**HARTZELL PROPELLER INC.**  
**SERVICE BULLETIN**  
**TRANSMITTAL SHEET**  
**HC-SB-61-287**

**Propeller - E10950 Blade Inspection, Rework, and Thrust  
Bearing Replacement**

June 5, 2009

This page transmits a revision to Service Bulletin HC-SB-61-287.

**Optical Comparator Overlay GT-3669, Rev. A  
Figure 3**

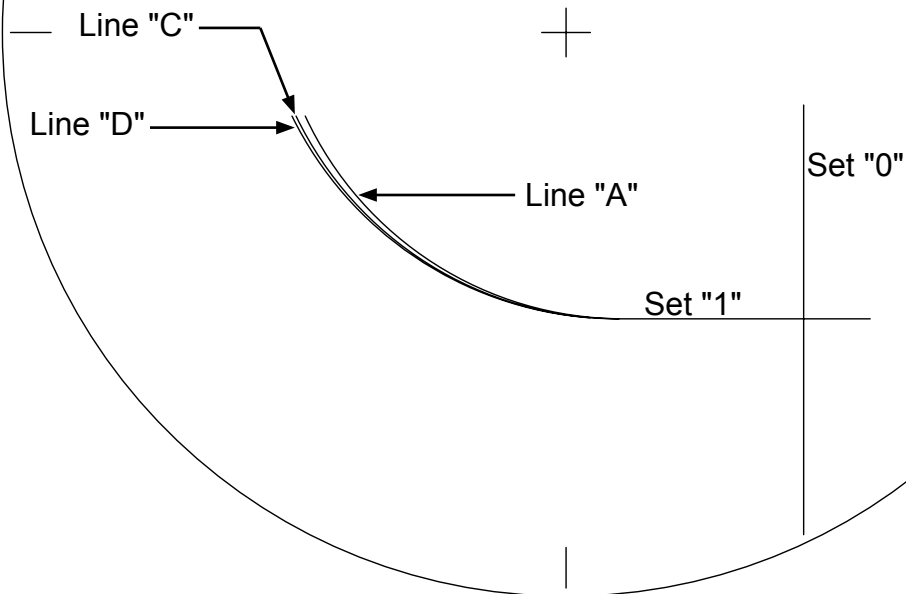
- Adds CAUTION for use of most current revision.
- Changes the compliance interval to 4,000 hours.
- Updates reporting requirements.
- Updates Figure 3 for latest revision of the overlay.
- Clarifies machining instructions for blades with the Delrin® seal installed.
- Clarifies requirement for shoulder height inspection following rework.
- Deletes the Appendix.

- (1) Use optical comparator overlay GT-3669, Rev. A TE451 to inspect the blade retention radius on the face and camber sides of the blade using an optical comparator.

- (a) Determine serviceability/repairability by comparing the projected image with the overlay. Make sure that the projected image is within the "A" and "D" lines. See Figure 3.

- 1 If projection is outside line "A", rework the retention radius in accordance with Paragraph 3.D. of this Service Bulletin.

- 2 If projection is between lines "A" and "C" retention radius is acceptable.

- 3 If projection is between lines "C" and "D", rework retention radius in accordance with Paragraph 3.D. of this Service Bulletin.

- 4 If projection is inside line "D", retention radius laminate repair is required. Return the blade to Hartzell Propeller Inc. for evaluation.
